Application No: 10/525,359
Amendment A
Response to Notice of Non-Compliant Amendment

Response to Notice of Non-Compliant Amendment

Appendix : Figures 1a, 1b and Figure 2

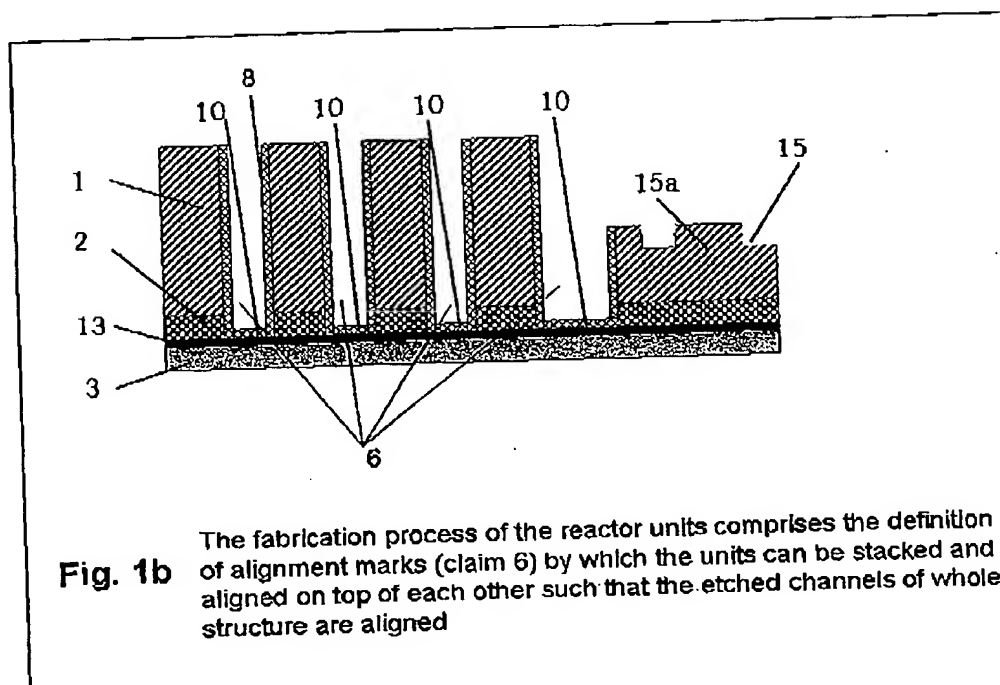
- a) either stacked on top of each other forming a hydrogen reforming reactor (see Fig. 1a + b in Appendix)

Applicants have drawn two figures to make the 2 variants of combining or stacking of the processed reactor segments clear.

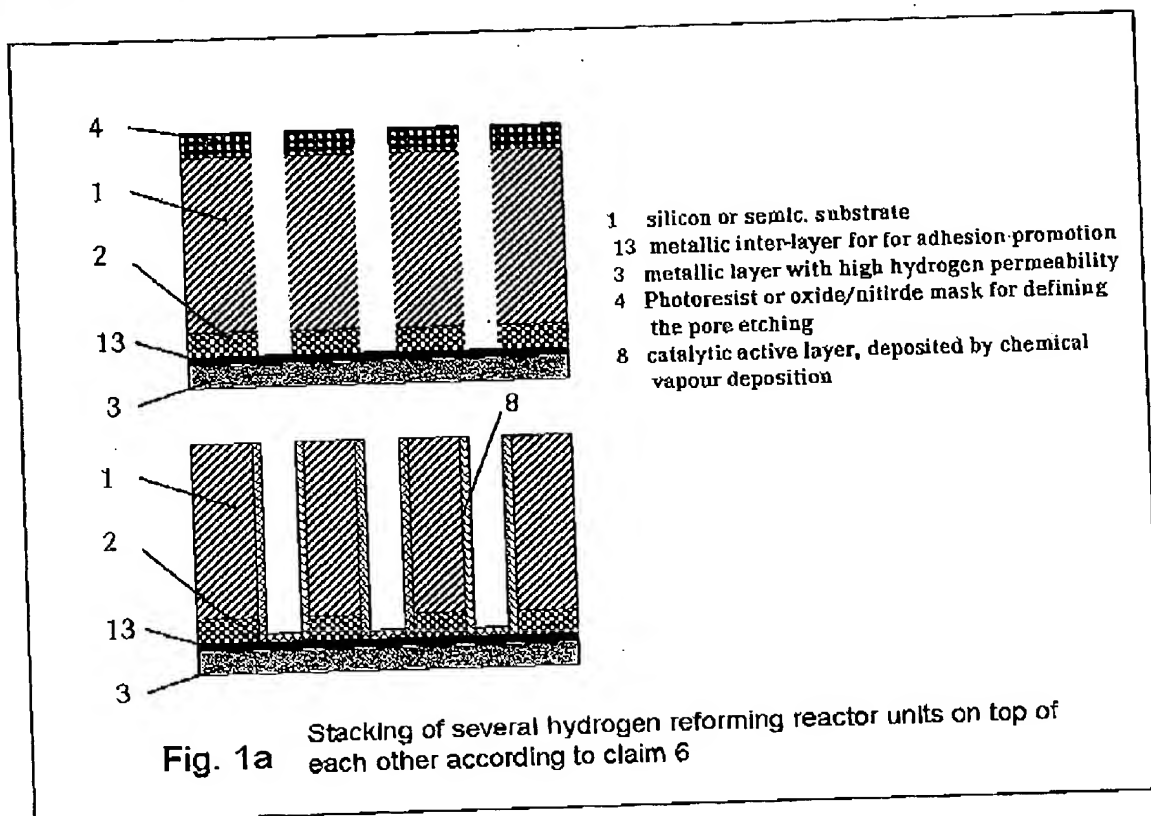
- b) two reactor elements can be combined to and oppositely aligned to an "interdigit" structure schematically depicted in Fig. 2 in Appendix . This structure is well suited to the envisaged application of steam reforming reactor which creates hydrogen for fuel cell systems.
